CITY OF WOODBURN
COMMUNITY DEVELOPMENT

MEMORANDUM

Date: October 5, 2020
To: Dago Garcia, P.E., City Engineer
Cc: Chris Kerr, AICP, Community Development Director
Roy Hankins, PE, Emerio Design
From: Colin Cortes, AICP, CNU-A, Senior Planner *cc*
Subject: **Planning Division review comments on 2nd submittal / 1st re-submittal
Sept. 18 of civil engineering plans for Smith Creek Development Ph. 3B**

SMITH CREEK PHASE 3B

CURB RETURN - S CORNER OF KILLIAN AND AUSTIN 7
1" = 5'

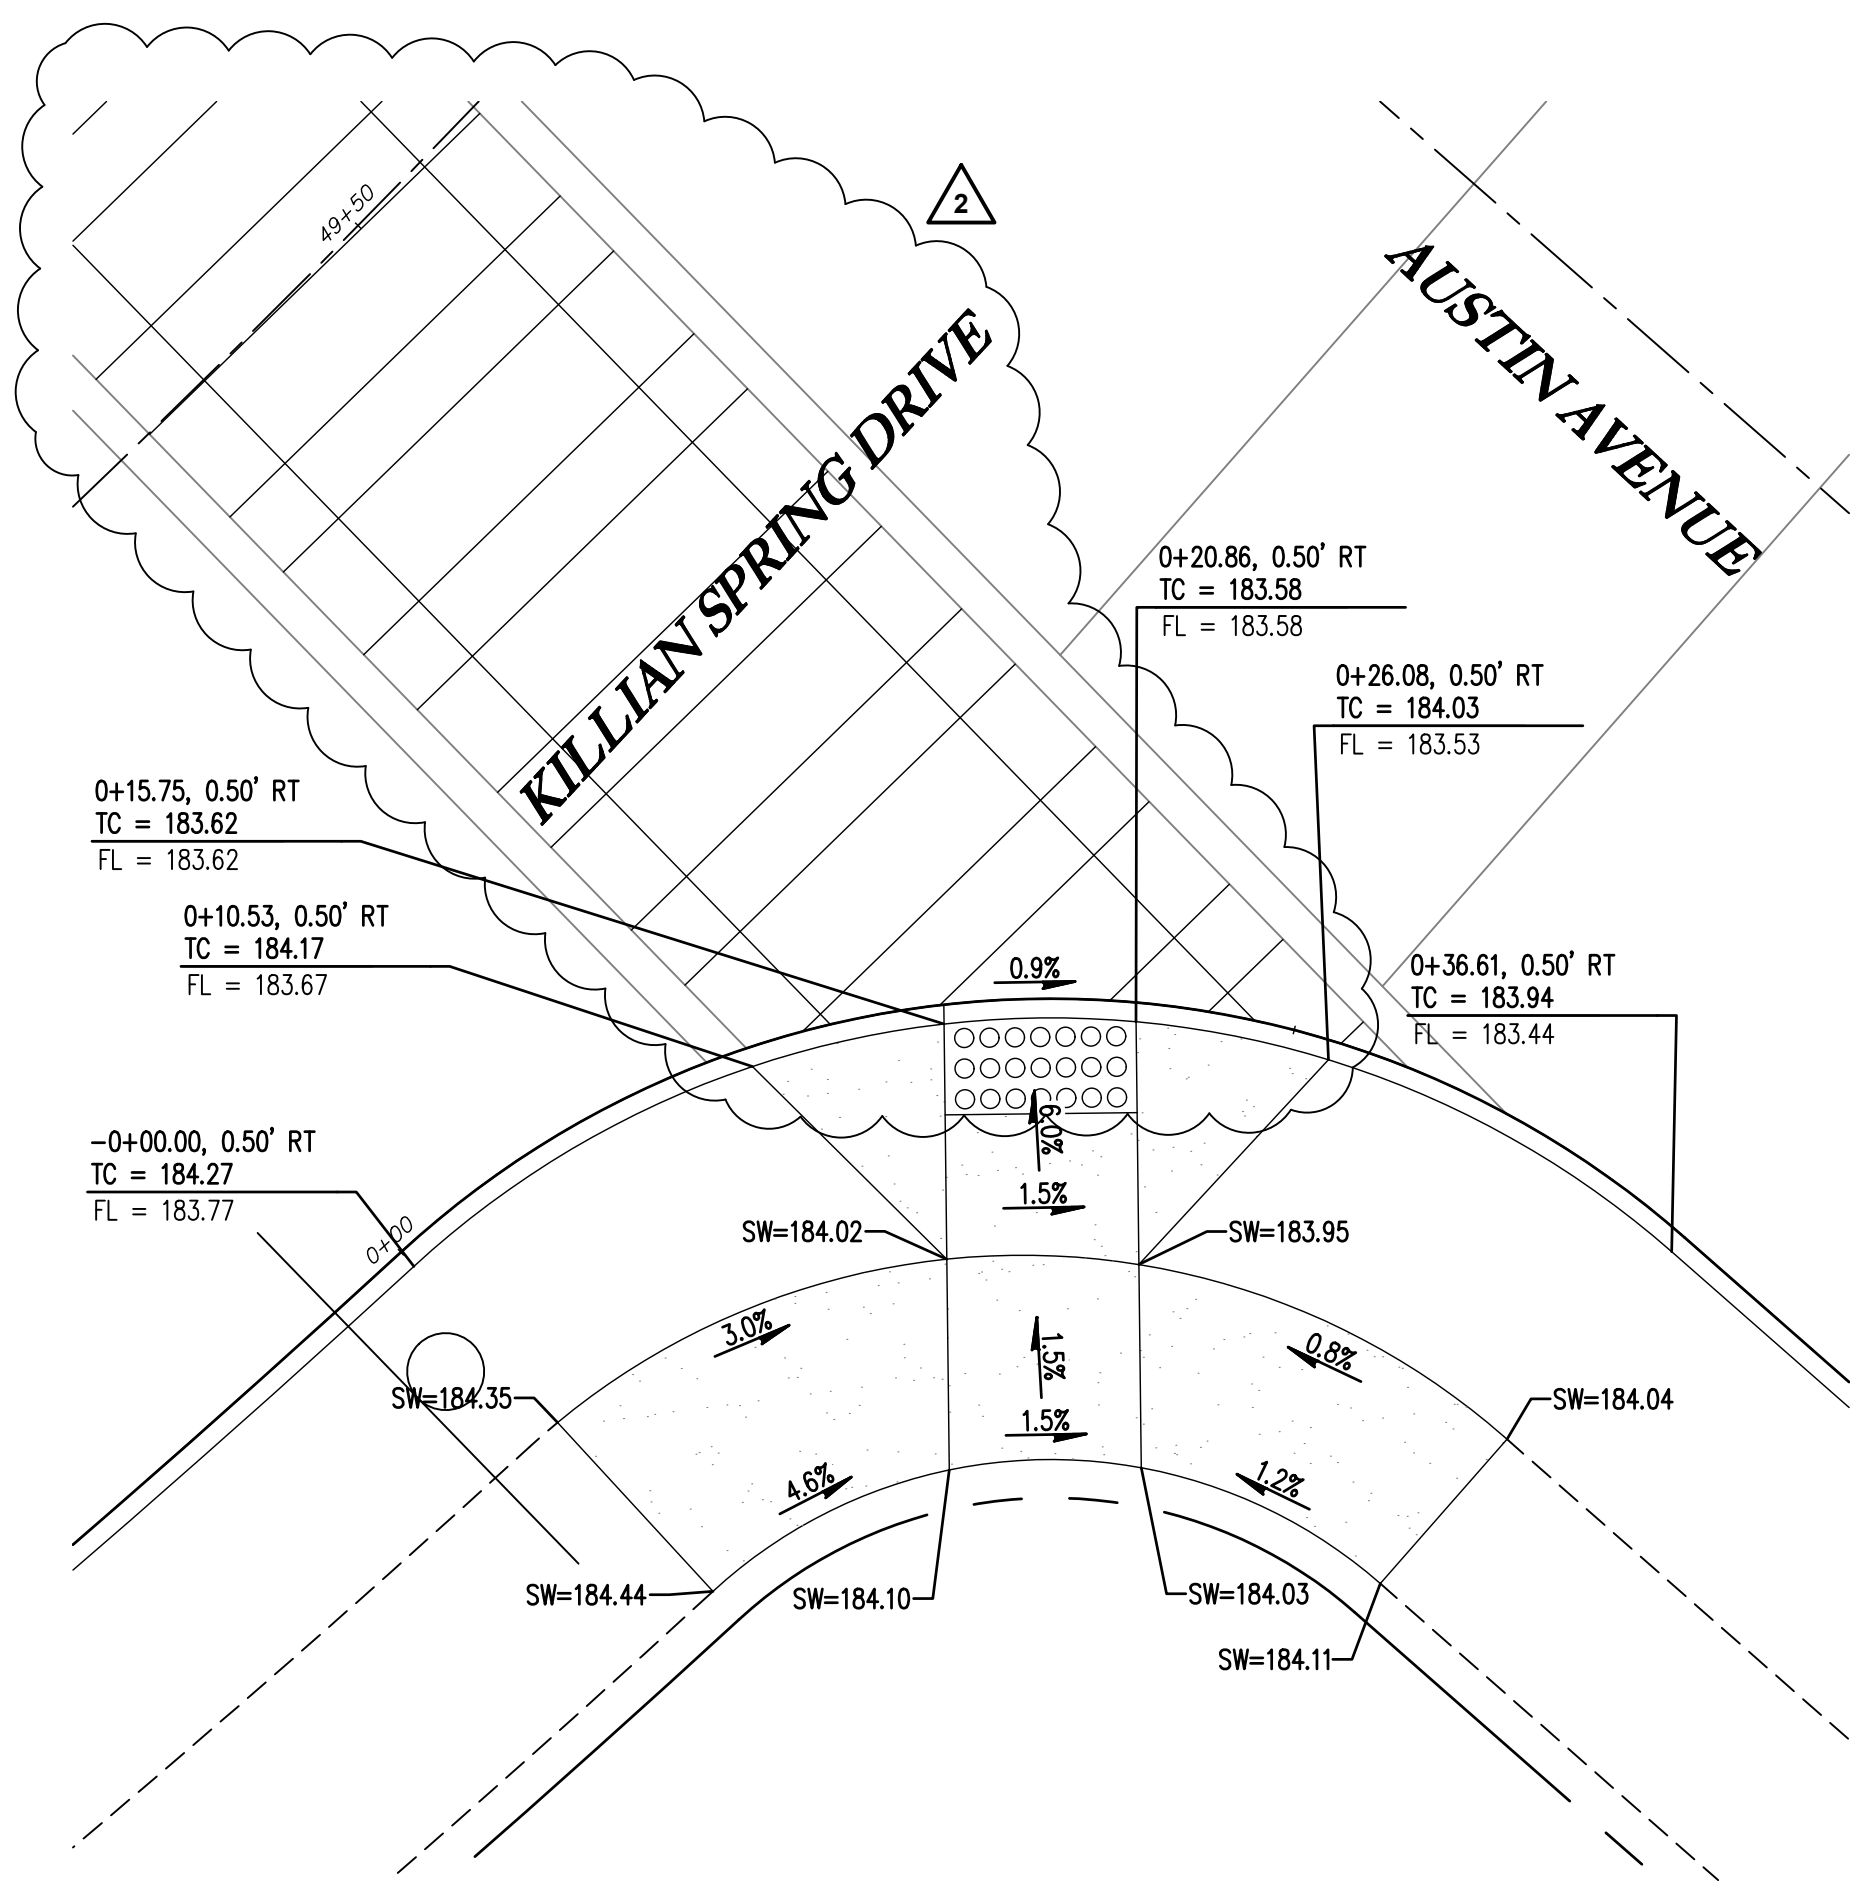
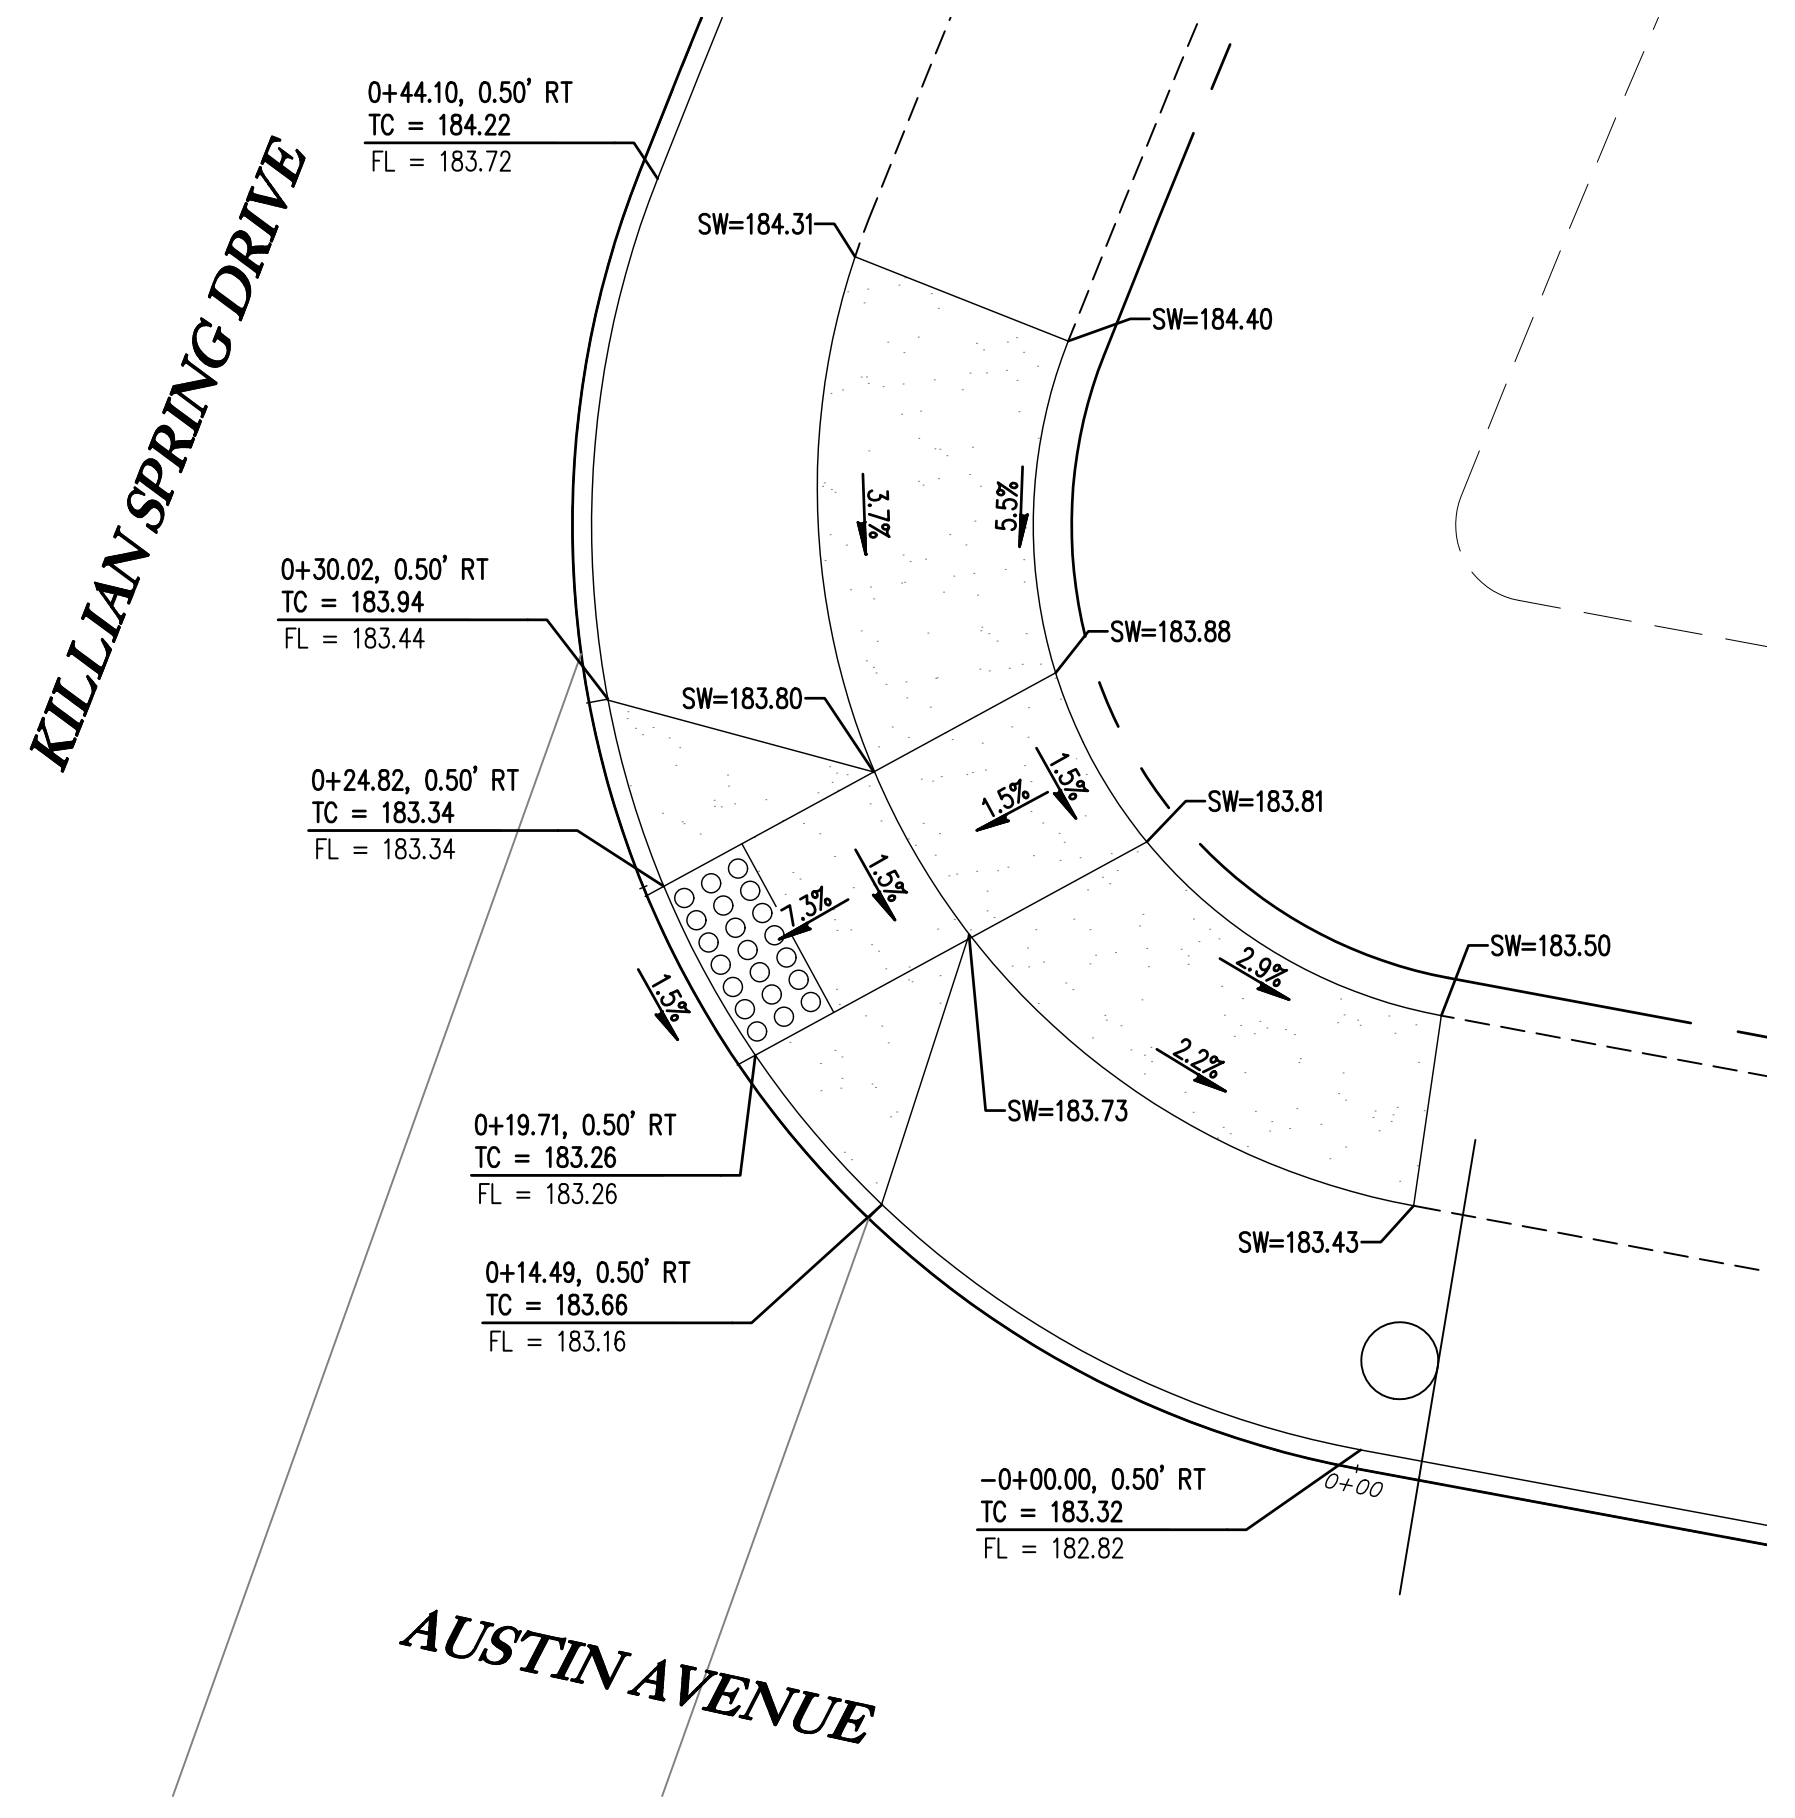
Sheet 3: Stamped concrete crosswalks typical section; and

Sheet 16: Curb return details 7, 9, 10, & 12:

The information is too vague to indicate pavement stamping/treatment, color, and pattern in conformance to the attached excerpted memo I'd sent Stafford Land Co. in August 2019 in response to a request to staff to direct on these topics when the issue first arose for Smith Creek through Phase 1A civil engineering plans.

Patterns: The pattern does not match any of the approved patterns. Thumbnail views of Attachment 1P are below:

Revise Sheets 3 & 16 accordingly.
